Service Bulletin

S.B. No: 187

Title: INSPECTION FOR CLEARANCE BETWEEN RUDDER PEDAL AND MIXTURE/PROP. SPEED BRACKET AND FOR GROUND TOWING DAMAGE. ALSO INCLUDES GENERAL RUDDER PEDAL CLEARANCES.

Applicability: T67M200 (Works No. 2264 & 2265 only), T67M260 and T67M260-T3A.

FIGURE 4

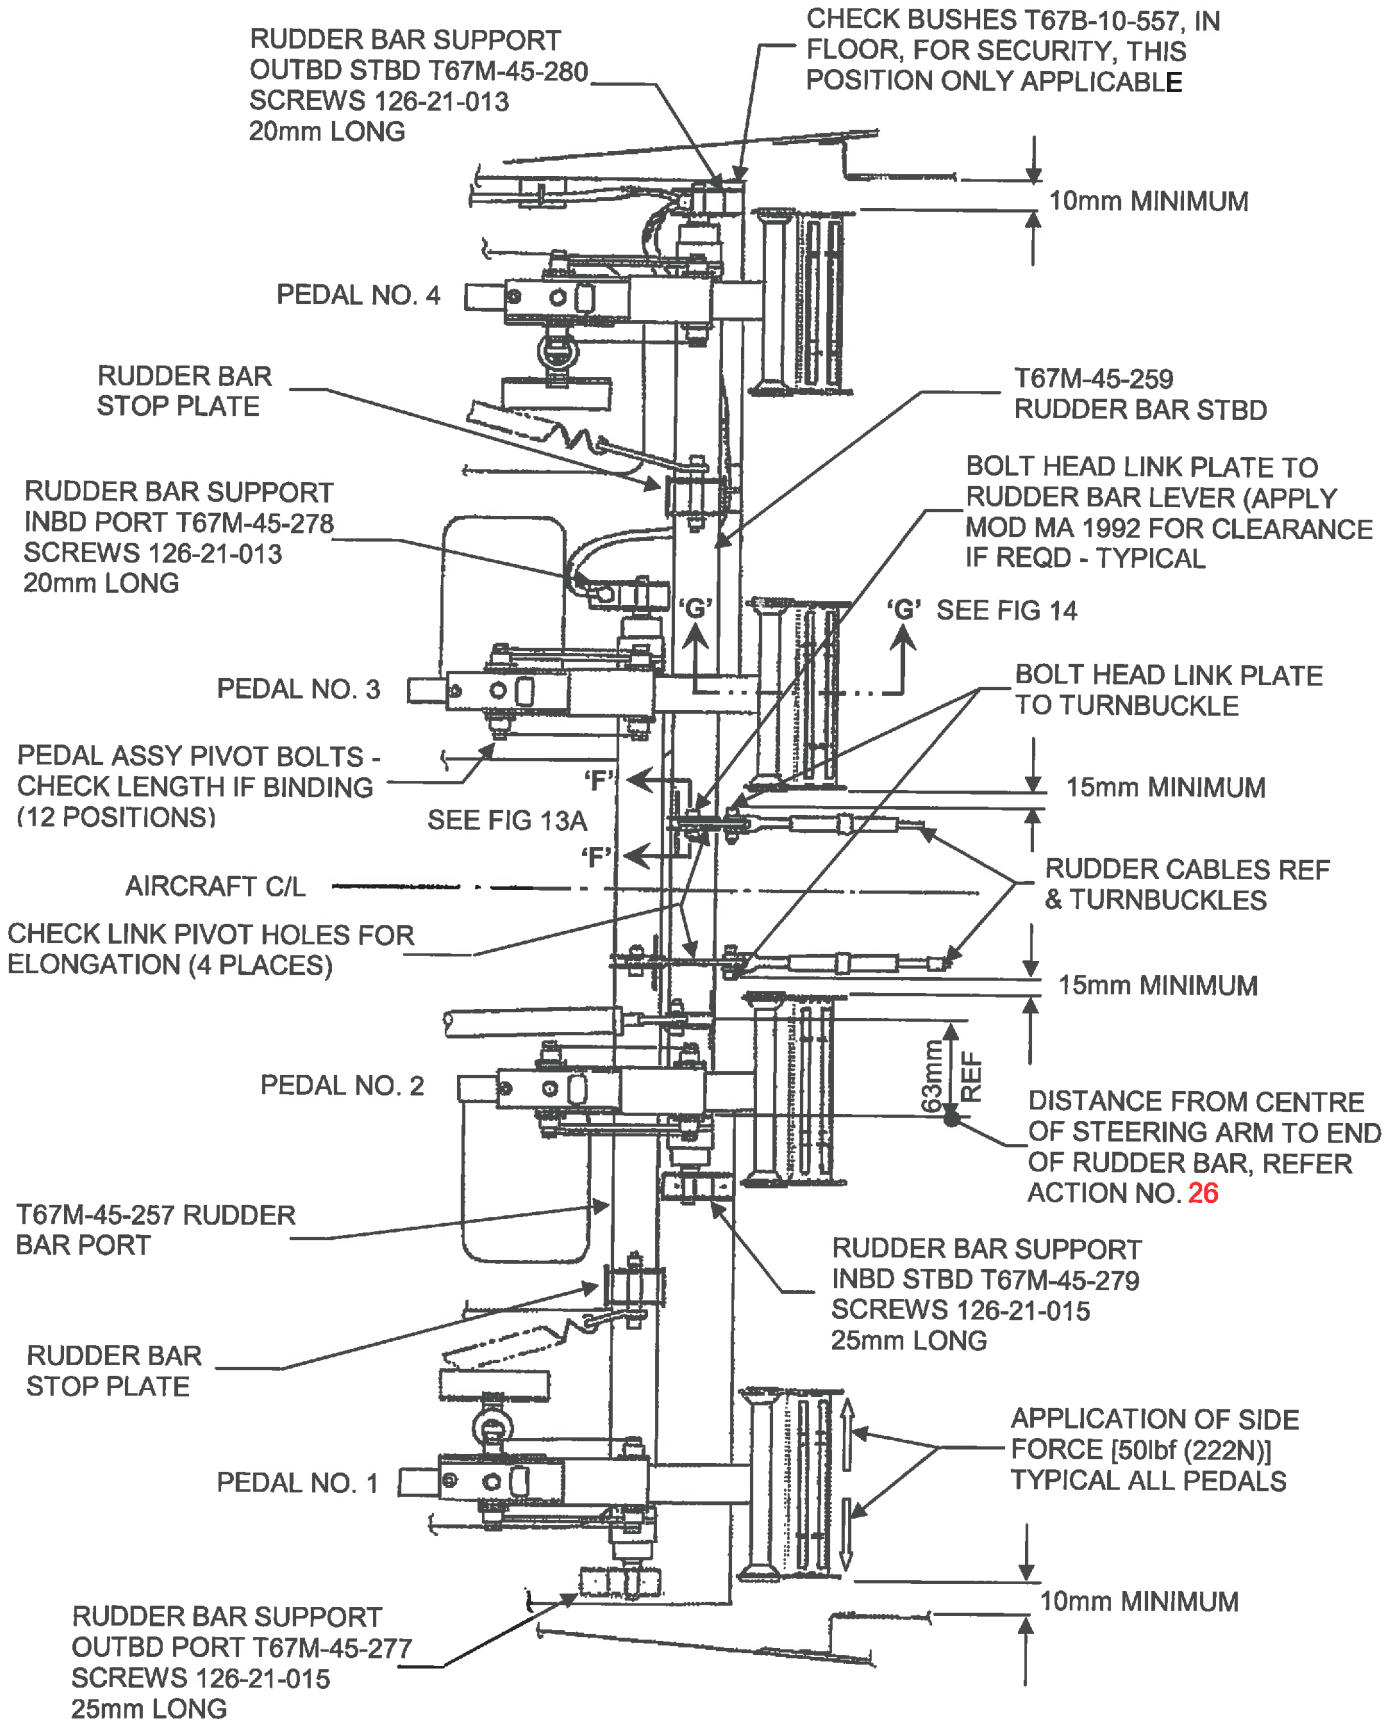
1. (a) Referring to Figures 4, 13A and 13B, check the Right Hand pilot's left pedal (Pedal No. 3) for clearances from: i) starboard rudder cable attachment bolts to link plate and ii) link plate to rudder bar lever post. Clearances should be a minimum of 15mm and 16.5mm respectively. Clearance checks to be performed at all four pedal adjusted positions, but especially; with pedal adjusted fully forward (or past last adjustment position), with full left rudder applied, together with a left hand side force applied to the pedal – refer Figure 4 – and that any slack in the rudder cable is taken up in the starboard direction - see notes below.

21. Upon completion of rudder movement set-up ref. Paragraph 19 above, ensure minimum clearances of trim panel to pedal side plates and rudder cable to pedal side plates are met Refer Figure 4. Refer paragraph 16 for packing washers.

FIGURE 5

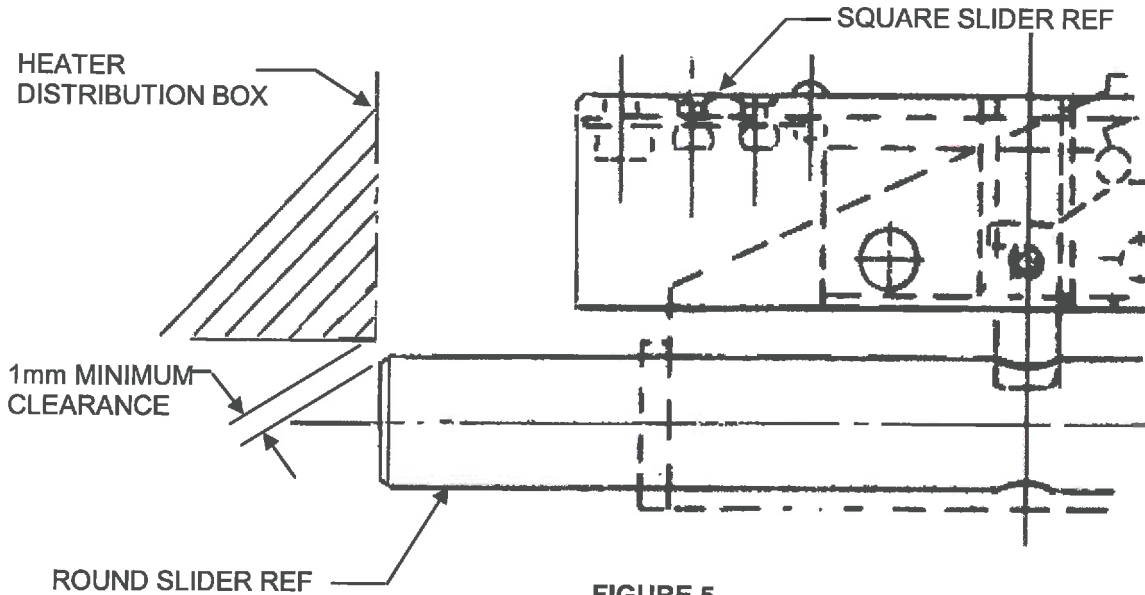
22. Ensure clearance of the no. 2 pedal slider to heater box clearance, is greater than 1mm, Figure 5 refers. Inform MSAC if clearance is not achievable.

FIGURE 7

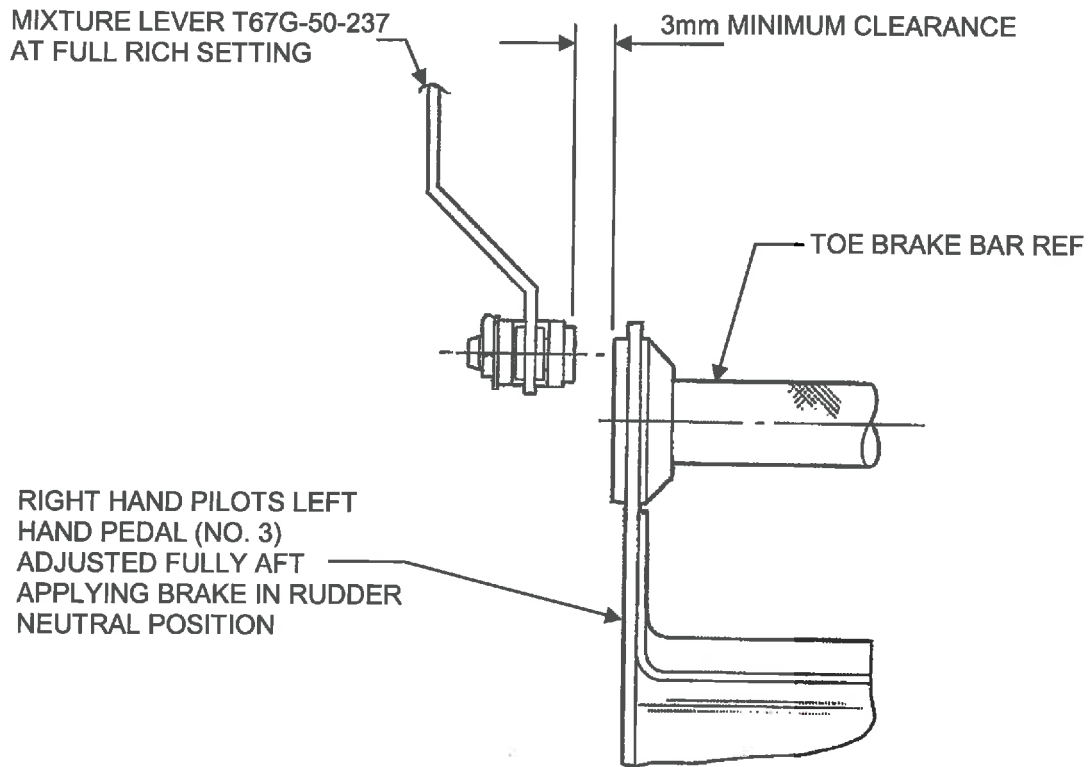
29. Ensure, that a minimum clearance of 3mm is achieved between Pedal No 3 and Mixture Lever operating arm, refer Figure 7. Ensure when Mixture Lever is operated its motion is parallel to aircraft centre line, if not rectify or replace Mixture Lever to correct motion. The clearance of 3mm is to be checked with Pedal No. 3 at all indented positions throughout the pedals range of movement and with a left hand side force – refer Figure 4 – applied to the pedal and the brake applied. Refer paragraph 16 for packing washers.

FIGURE 9

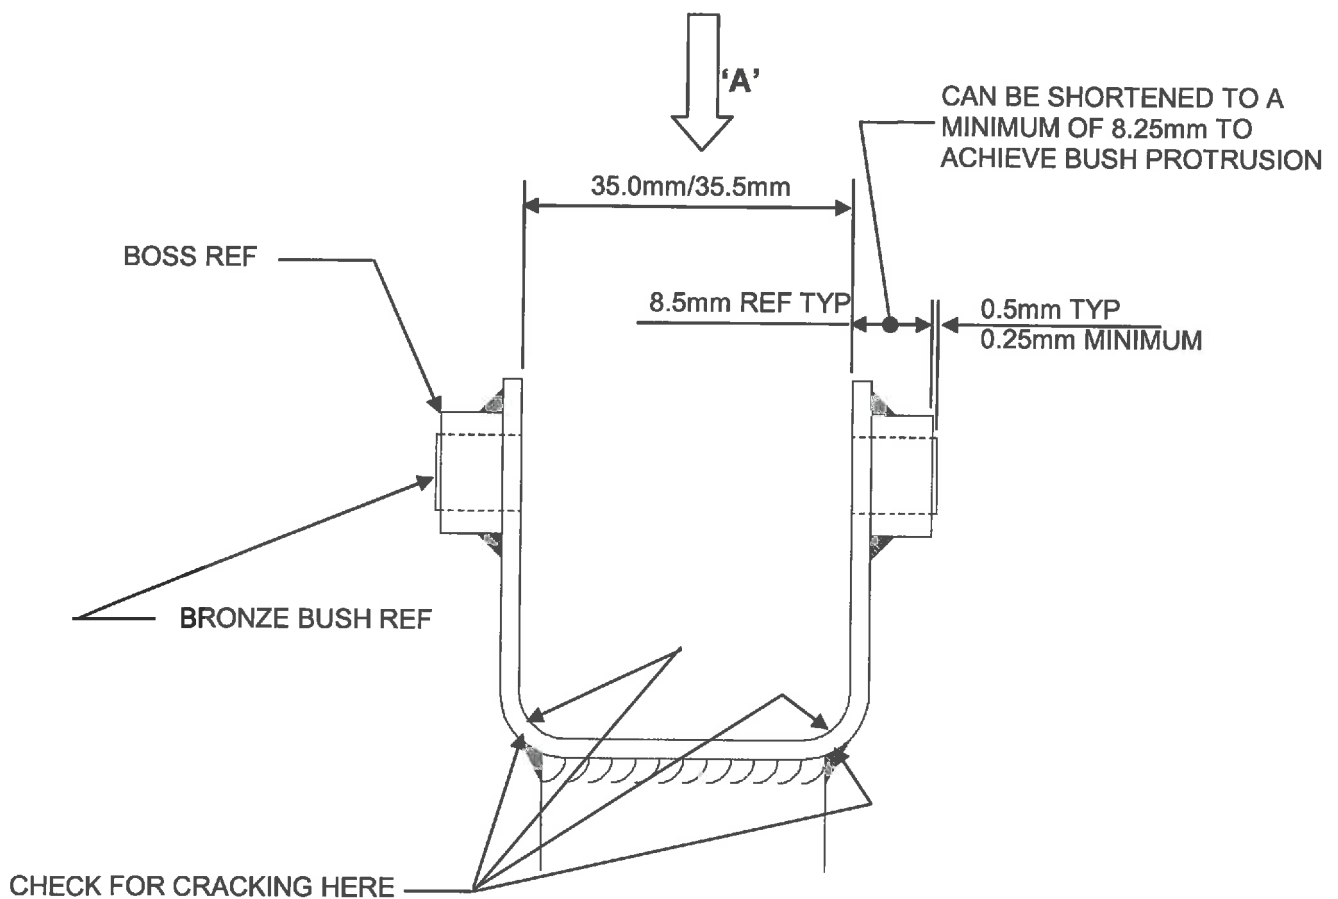
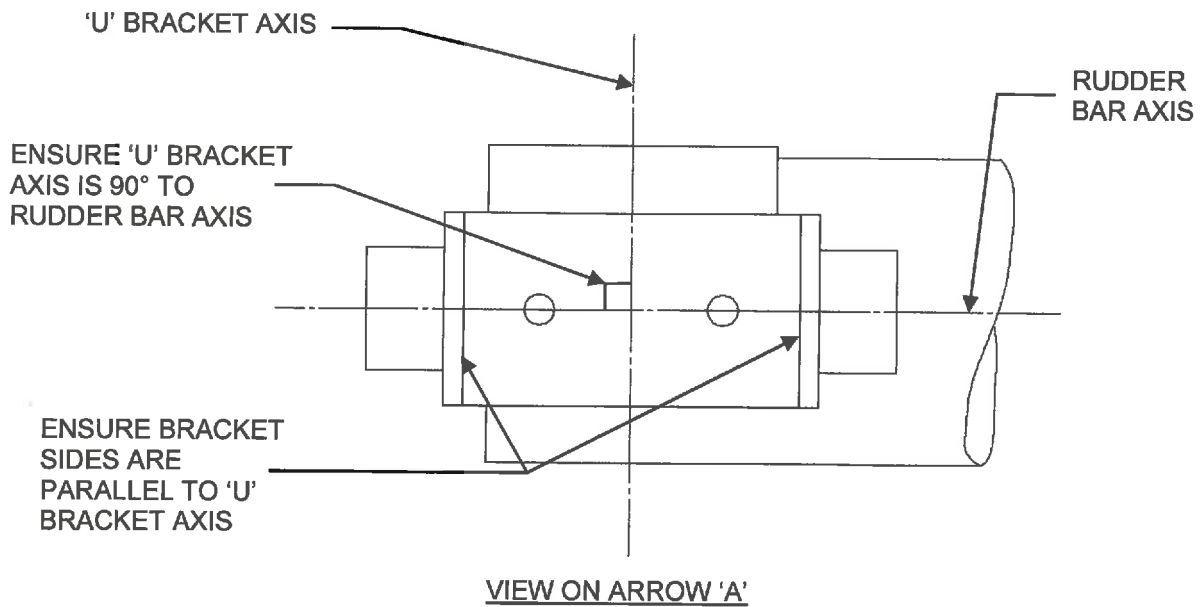
17. Check that the 'U' brackets are free of any deformation, and are parallel and square to the rudder bar axis, Figure 9 View on 'A' refers. This alignment is important at rudder position 3 with reference to attaining the required clearance between pedal and mixture bracket, ref paragraphs 2 and 3. Also ensure that the rudder pedal carriages have full and free movement. If binding is suspected then check the 'U' bracket internal dimension. This should measure 35.0mm to 35.5mm, also check that the pivot bush protrudes from its boss by at least 0.25mm, see note 3 below. If the bracket internal dimension is greater or less, or if out of alignment then the bracket should be checked for cracking, refer Figure 9. If cracking is found then return rudder bar to MSAC for rework. Finally check length of carriage pivot bolts, reference Figure 4, if binding is noted then replace bolts with bolt part number T67B-08-537 this introduces a bolt 15 mm long, measured from under head, and invokes Mod M808 "Introduction of Shortened Pivot Bolt to Rudder Pedal Slider Assembly Mounting". Also refer to SB130 "Inspection of Rudder Pedals for Adjustment Restriction".

FIGURE 10

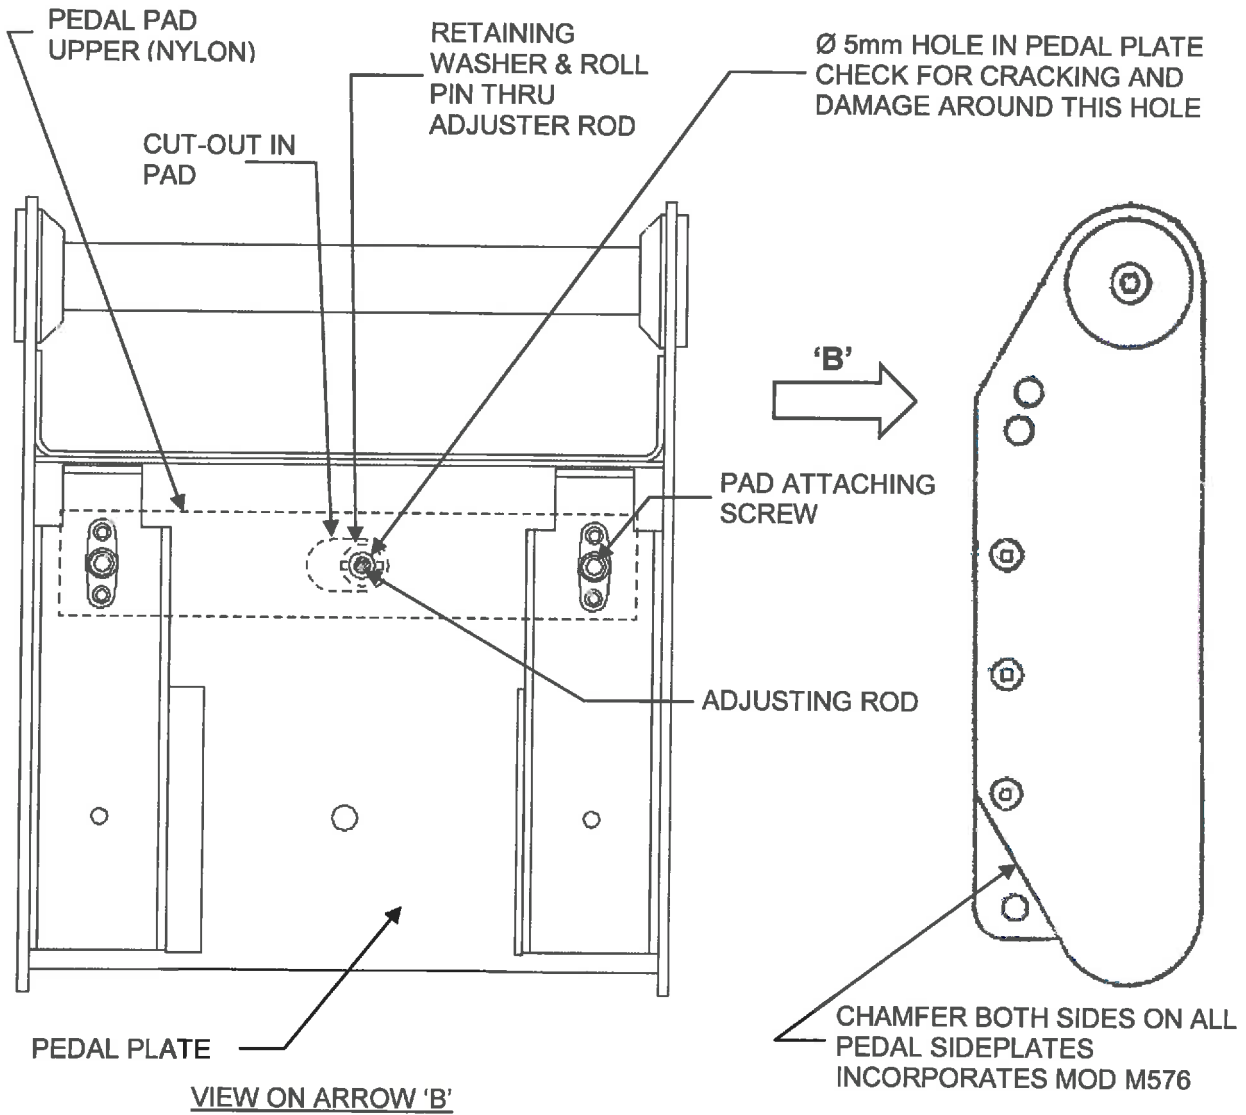
30. Ensure Mandatory Mod M576 "Introduction of Rudder Pedal Pad with Chamfered Side Plate" has been invoked; CAA AD 013-05-94 refers. Pedal side plate should be as Figure 10.

31. Check structural integrity of pedal pad assembly especially around adjuster pushrod hole pedal plate, Figure 10 View on Arrow 'B' refers, if plate is cracked or damaged the pedal pad is to be repaired. Ensure riveting is secure, if rivets are loose then they have to be rectified. Ensure that the pad pivots are not worn and that the nuts are tight, but allow pad to pivot, nuts to be retained with adhesive 126-51-067. Replace pedal pads if worn. Contact MSAC for new pedal pad assembly, materials and any applicable repair scheme.

FIGURE 11
BRAKE MASTER CYLINDER SUPPORT BRACKETS

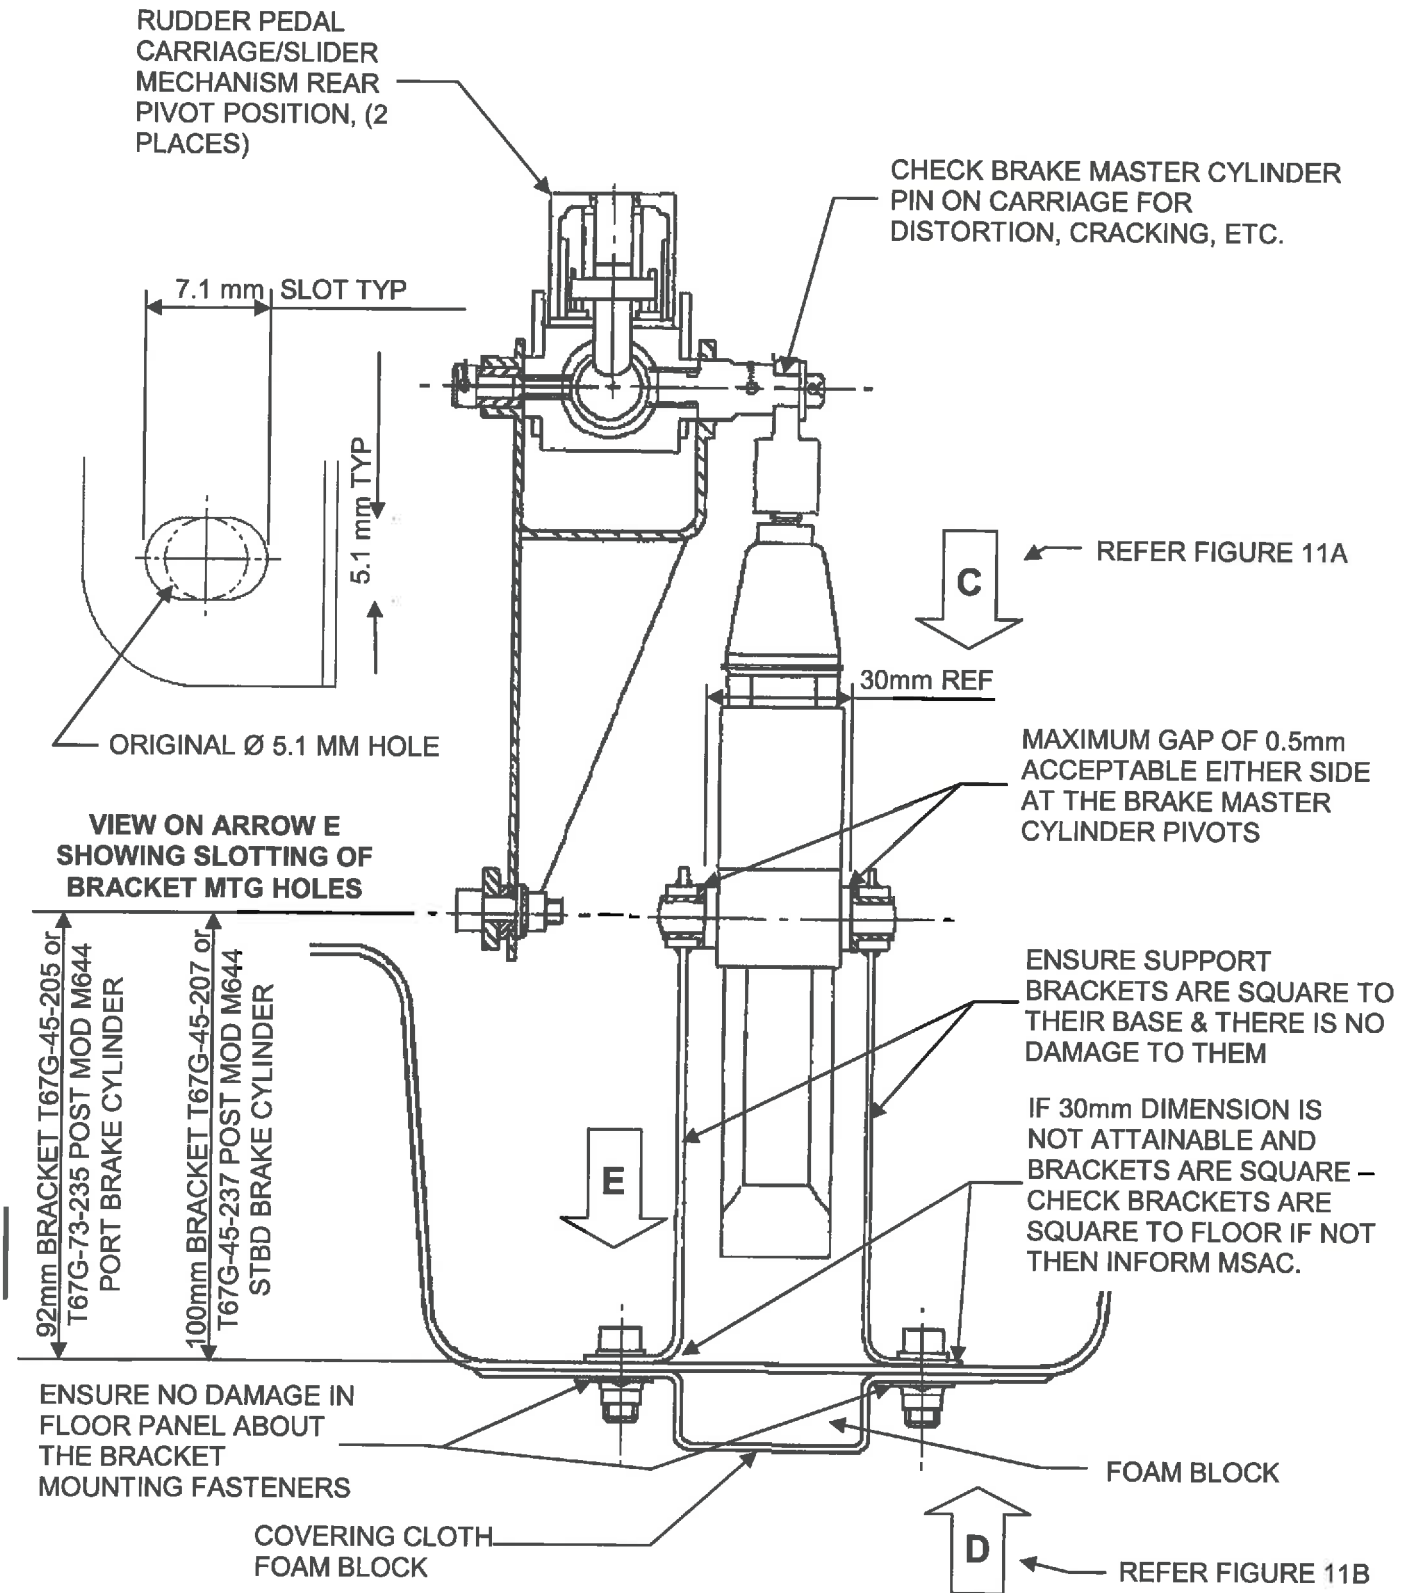
12. Referring to Figure 11, ensure that there is either no gap or a gap either side no greater than 0.5mm, at the brake master cylinder pivot points and that the support brackets are securely mounted to the floor panel, i.e. not loose. Brackets should not deflect if base fastenings are sound. If bracket is seen to be suspect, i.e. out of square, twisted or bent, remove brackets and replace with new brackets if damaged. Check that there is no damage to the bracket anchorages in the removable floor panel. Damage will show as whitening in the laminate surrounding the anchor nuts and foam reinforcement block, ref. Figures 11A and 11B, if in doubt remove panel and check anchor nuts for security. Figure 11 refers. If the floor panel is found to be damaged it is to be repaired or new panel fitted, refer to MSAC Product Support Department. If damage found then proceed as indicated by paragraphs 13 and 14. When rectified ensure all clearances and checks are accomplished as related to in this Service Bulletin.

Ensure that the rudder pedal/brake system brake cylinder support brackets are assembled in their correct positions. The port side cylinder support brackets are shorter than their counterparts on the starboard side and must NOT be interchanged. Cross check with the approved aircraft maintenance manual for the correct part number of each bracket and its position in the aircraft. Figure 11 refers.

14. If damage is found ref. Paragraph 12, then brake master cylinder to rudder pedal carriage attachment pin is to be checked for deformation/cracking, Figure 11 refers.
